Technical Service Bulletin: TSB110152

K19 and QSK19 Flywheel Balance Holes Drilled in the Incorrect Location

Picture 1: Holes drilled in the incorrect location (Surface 2).

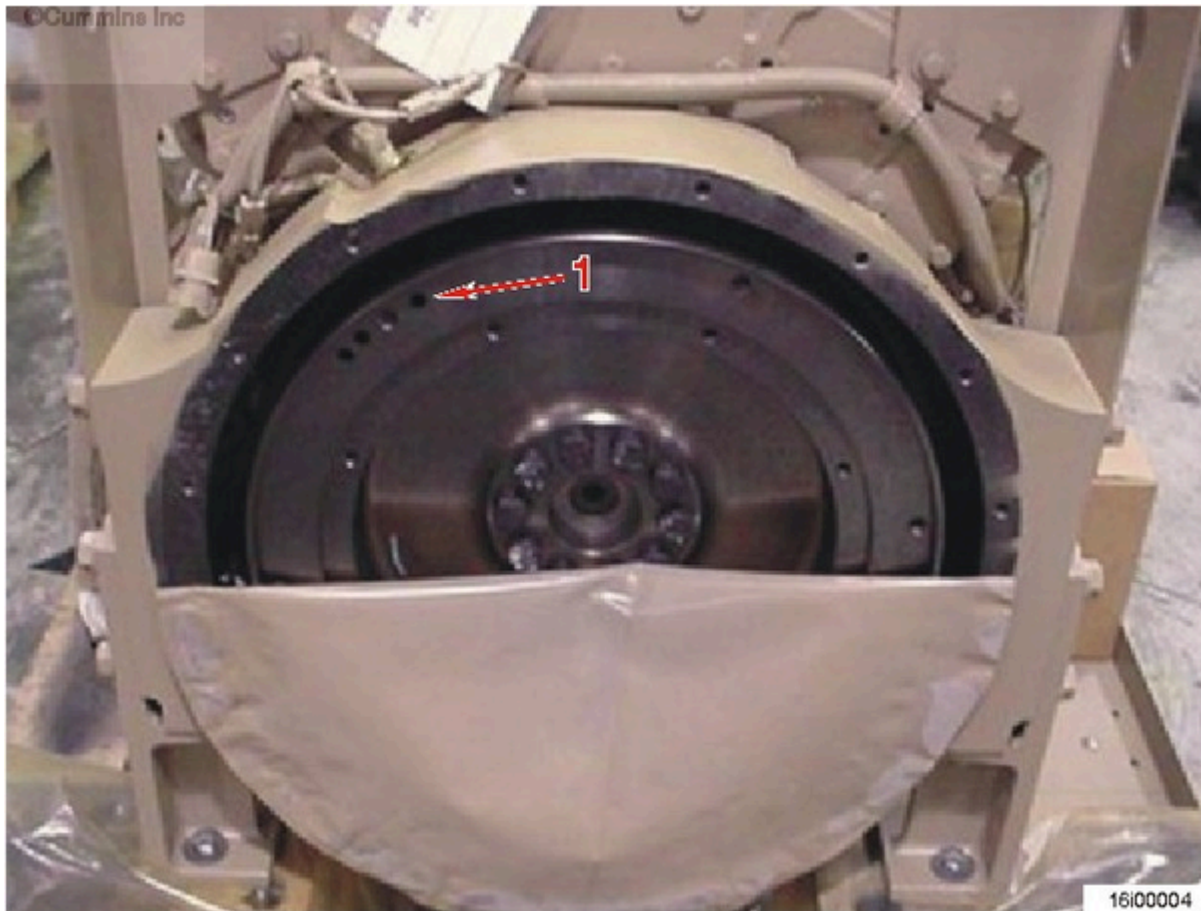
The K19/QSK19 flywheel balance holes were drilled in the incorrect location on Part Number 3090758, and 3024105 flywheels. The flywheels are permitted for use and will have no effect on engine performance or durability. These flywheels have been installed on production engines and sold as service parts.

The balance holes in the flywheel should be on the outer most ring of the rear surface (1), but have been drilled on one of the inner rings (2). This is due to a supplier production error and does **not** affect the performance of the flywheel.

Flywheels with balance holes in the incorrect locations are permitted for use and will have no effect on engine performance or durability. These flywheels are **not** defective and should **not** be returned.
